DETENTION BASIN STAGE-STORAGE TABLE BUILDER

Project: Villas at Aspen Trails

Basin ID: Pond-1

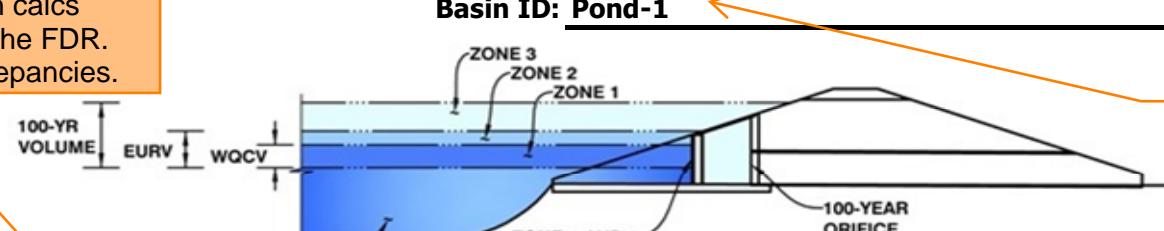
Inputs do not match those shown on the MHFD-Detention calcs shown on pdf pg 48 of the FDR. Revise to remove discrepancies.

Labeled as "South Pond" in MHFD-Detention spreadsheet calcs. Revise to remove discrepancies.
